1150 Eastlake Ave E

SDCI Project # 3026536

Design Review Board Recommendation

West Design Review Board
March 13, 2019

View of Main Entry

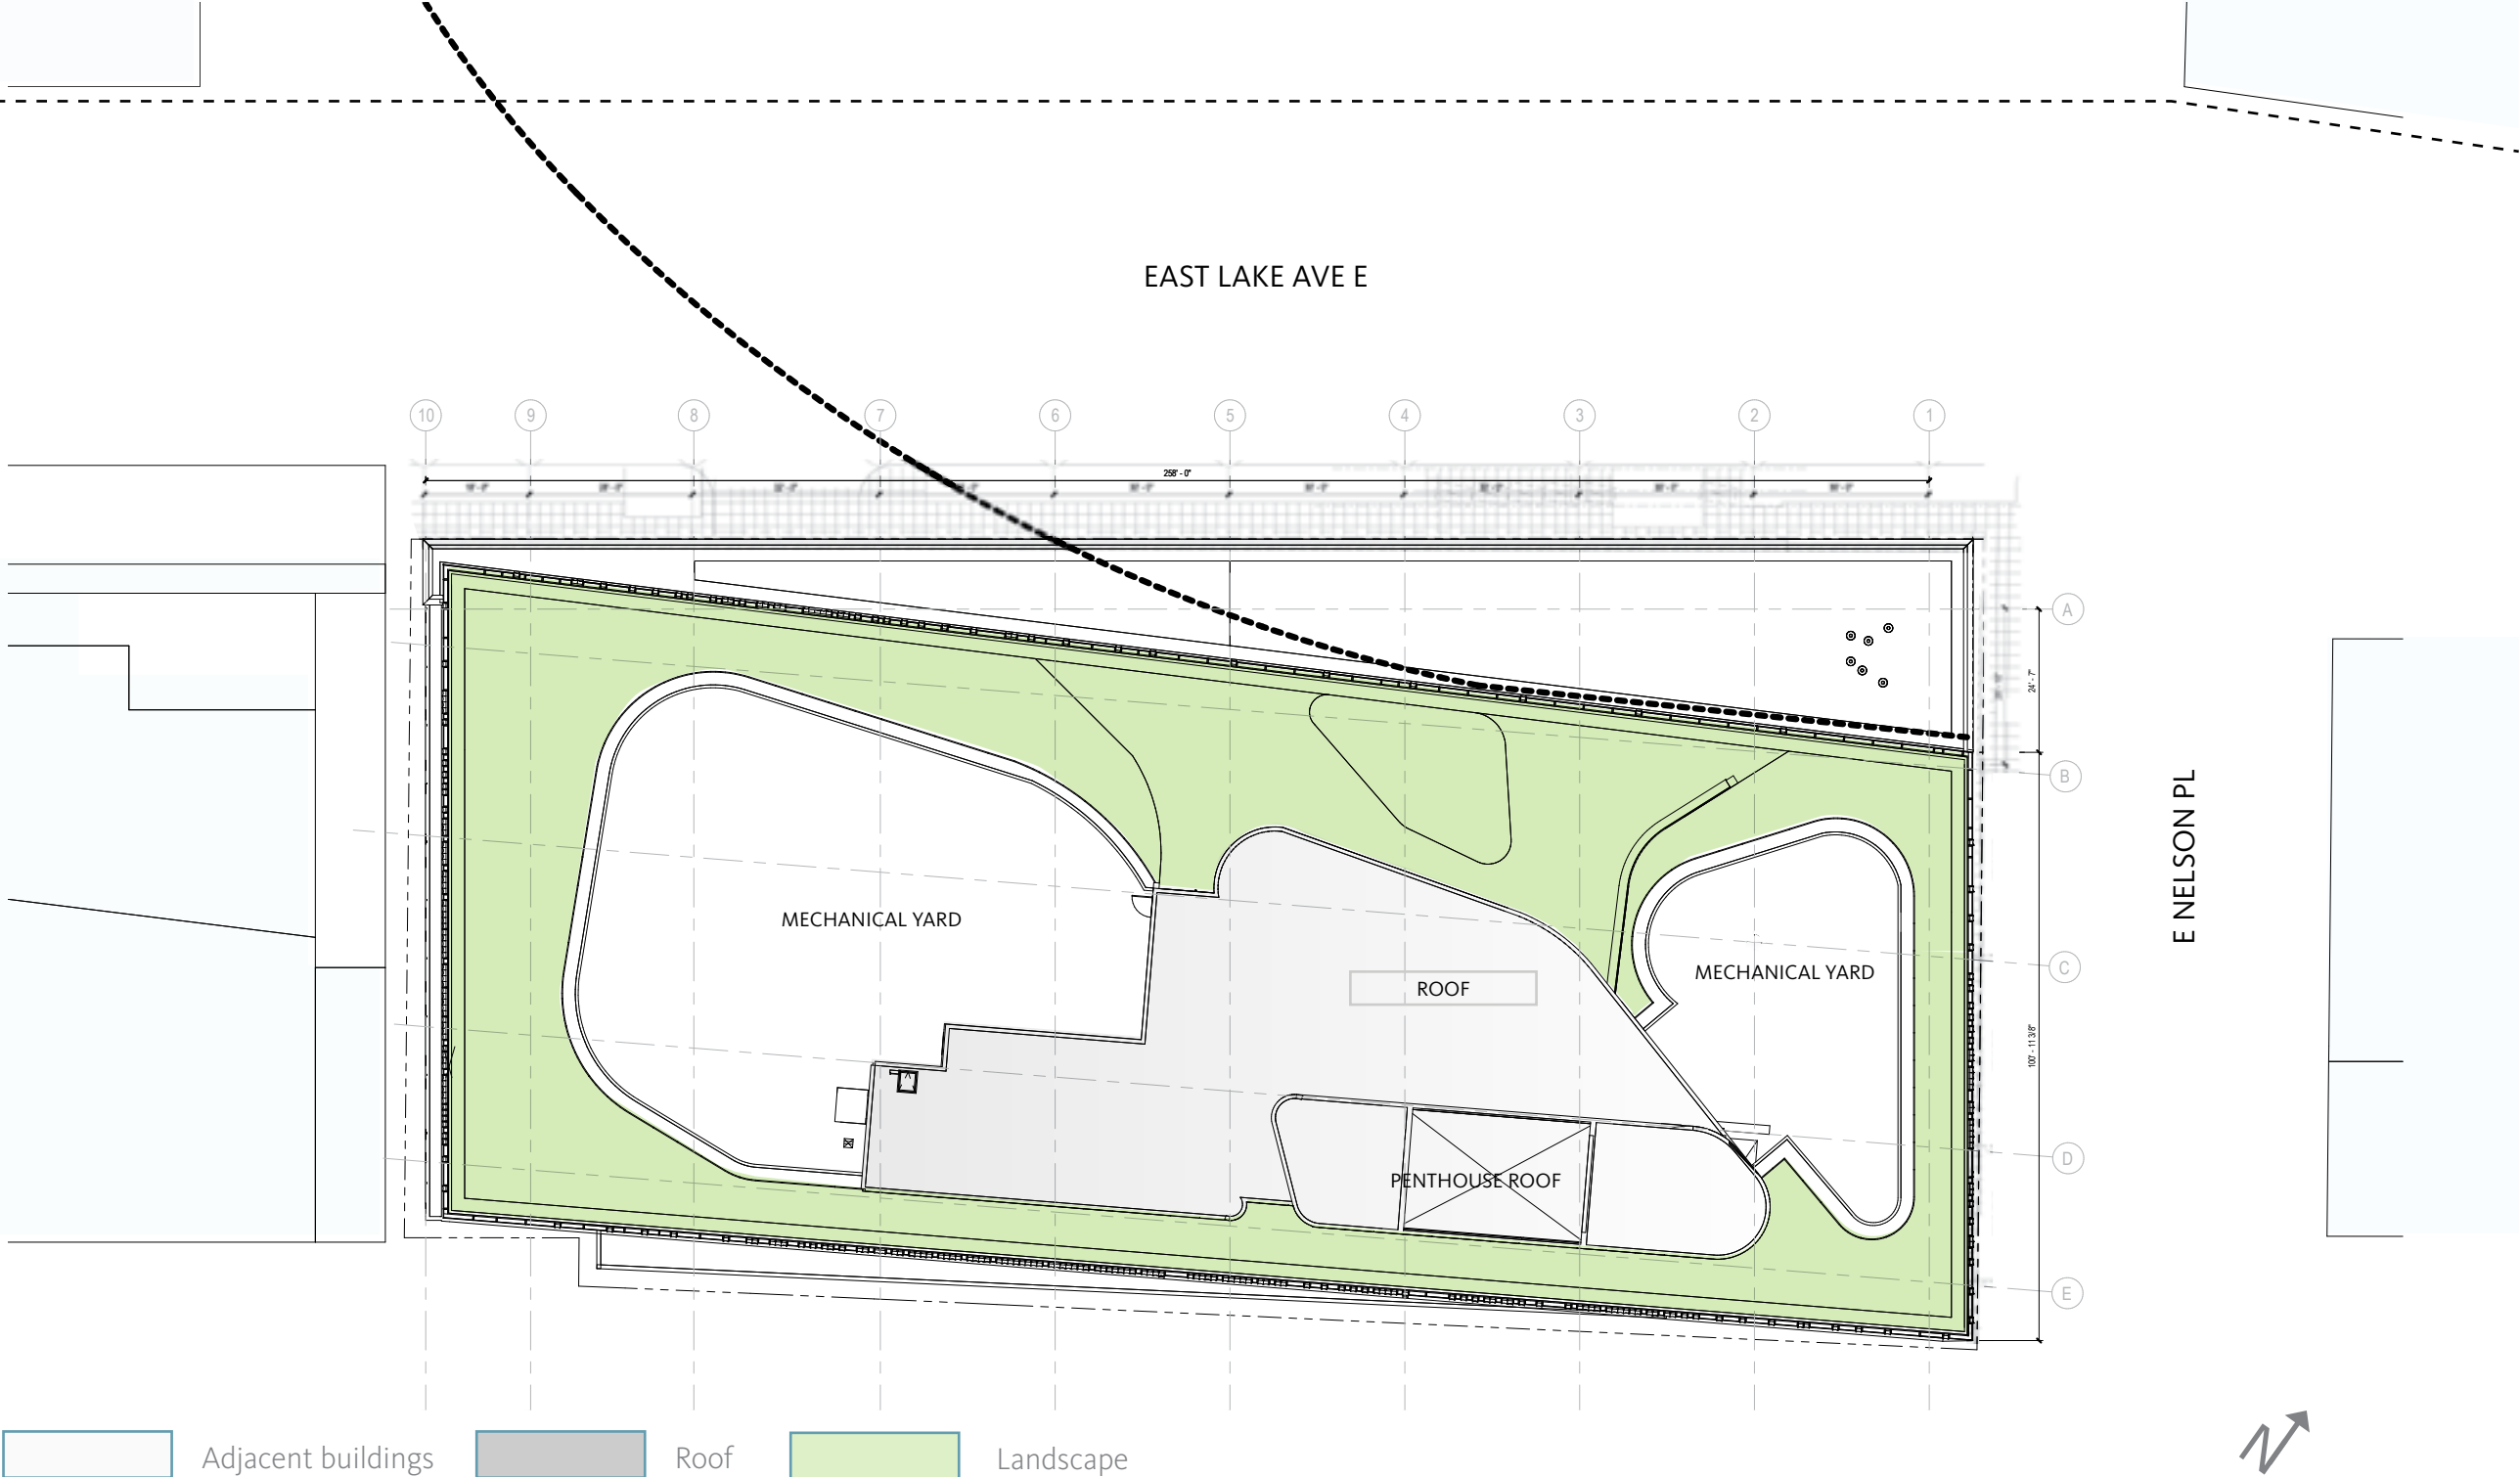
“The Board noted that the building and sidewalk relationships to the steep grade of Nelson Avenue should be carefully designed to avoid high walls and cumbersome grade changes. Create good transitions around the corner for visibility and ease of access.”

The refined plaza design softens the transition of the steep slopes to the entry plaza.

- Glass guard rail allows direct visibility into plaza
- Interior feature wall carried into the plaza to extend the inviting lobby out to the sidewalk.
- Sculptural entry feature visually and physically connects the entry plaza to the terraces and forest features of the tower above and diminishes the influence of the adjacent steep slopes
- Sculpture feature marks the main entry to the building and makes a memorable corner for pedestrians

10.0 DEVELOPMENT STANDARD DEPARTURE: Curb Cut/ Access (Guidelines CS-1, CS-2)

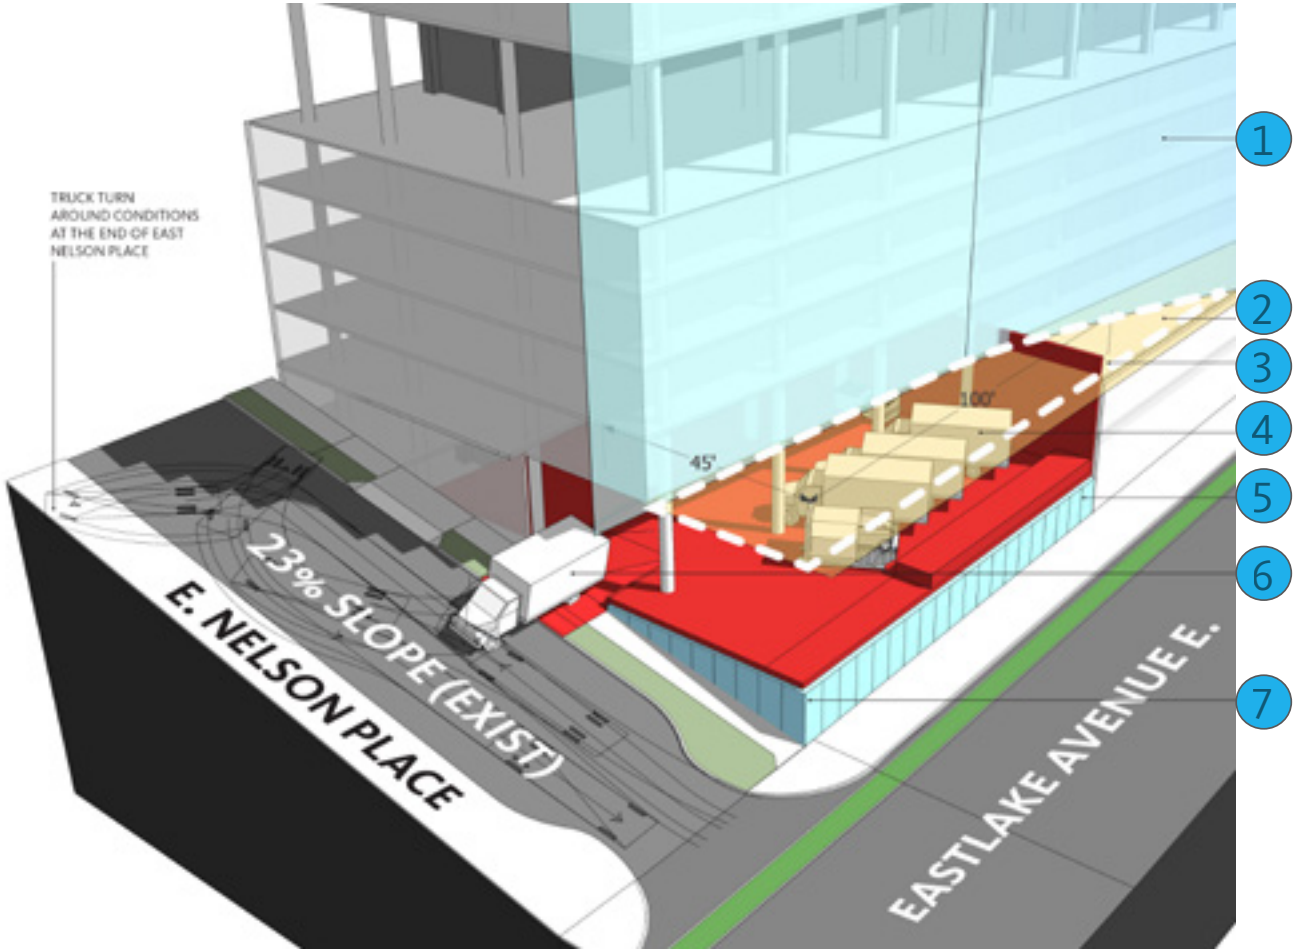
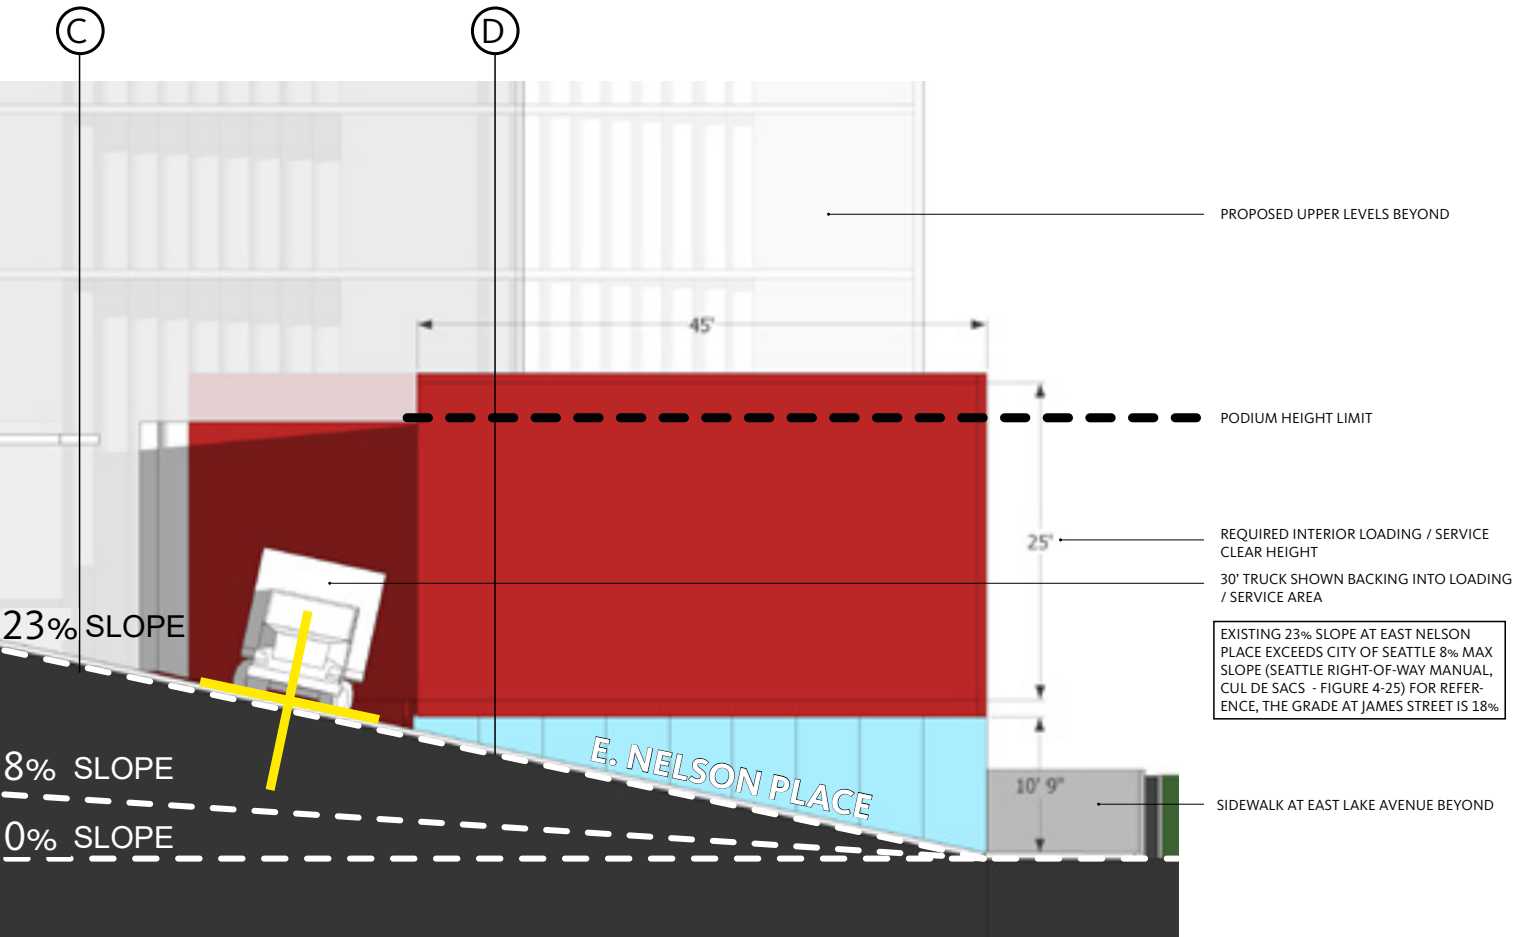
“The Board discussed the departure and were supportive of the second curb cut for access with more information from the applicant on how transportation, parking and bicycles will work at the site. They thought the proposed departure could fit into the building façade language, but wanted more information at the next meeting. The Board asked the applicant to research design rationale for the request and to provide more building ground level information.”

The request is revised to a single curb cut **on the arterial**.
The departure request to locate the curb cut on Eastlake Ave E in lieu of E Nelson Place is in response to guidelines CS1 and CS2, as well as DC2 and PL2.

- The intersection of E. Nelson and Eastlake Ave E provides a critical pedestrian connection to the historic Steam Plant building, other local buildings within the developer’s emerging campus and the transit that flanks the lake beyond. It is therefore the natural entry point for this project.
- The design provides a visually engaging focal point that draws the forest concept to a pedestrian scale but also provides opportunities to attract pedestrians from throughout the corridor.
- Varying the scale and proportions of the podium facade at E. Nelson
